E4095A/B-02-S

S E R V I C E N O T E

HP E4095A/B PT500 Protocol Tester

DATE: 03 January 1994

PT BACK BEZEL GROUNDING WIRES UPGRADE

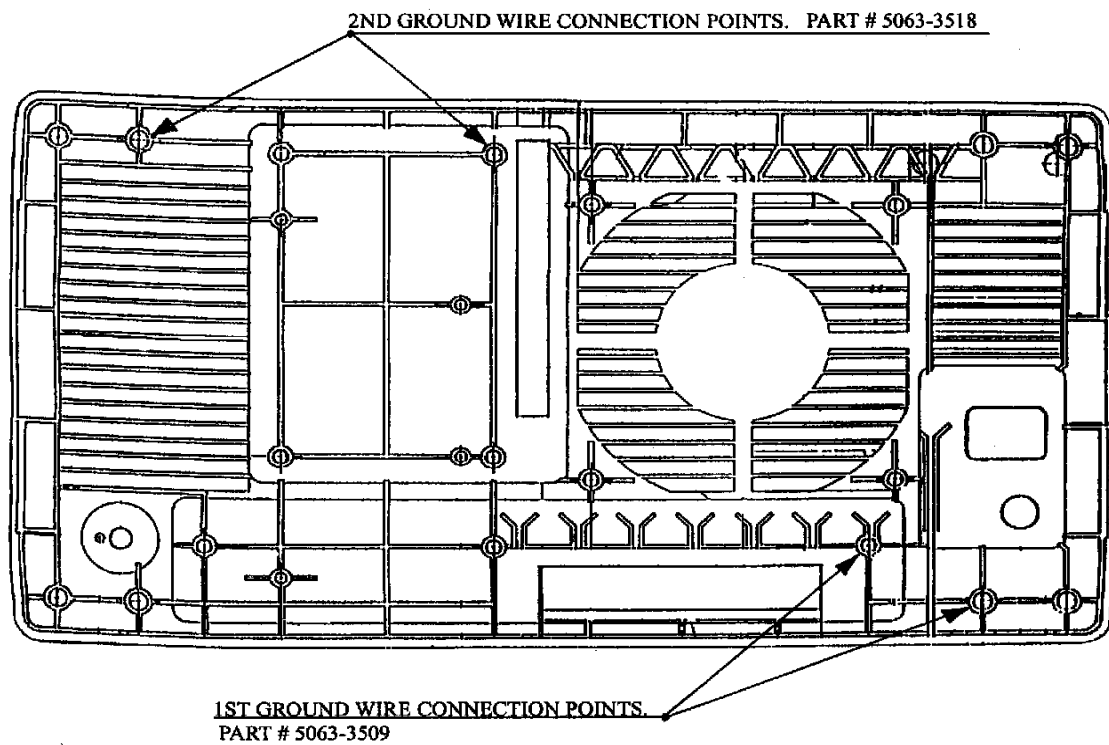
The grounding paths between connector module plates, handles and chassis ground does not meet Hewlett-Packard safety requirements. ITO manufacturing has rectified this situation for current production as of 1993 August 20.

Affected units must be retrofitted with grounding wires to rectify the problem, using the following instructions.

- Remove top cover of instrument and interface module.
- Install longer (11 cm) ground cable, p/n 5063-3518, to existing screw of upper left hand side member bracket hole.
- Connect to inside connector module hole, beside degaussing board, with 4x5 screw.

- Remove bottom cover of instrument and auxilliary connector module.
- Install 8 cm ground cable, p/n 5063-3509, to right hand side hole of auxilliary connector with 4x5 screw.

- Connector module handle should be grounded from the rear handle screw to the nearest DB style connector screw by installing one of the 5063-3510 wires between these two points.
- Use the four 4x28 screws to reinstall connector module.

- Applies only to MPT368.2, IPT468, XPE systems with no parallel printer connector, that is, with auxilliary connector module 4010-0070-IDA.
- Install grounding wire between the handle mounting screw and the nearest screw of the "PRINTER" connector.
- Reinstall auxilliary connector module using three 4x25 screws.
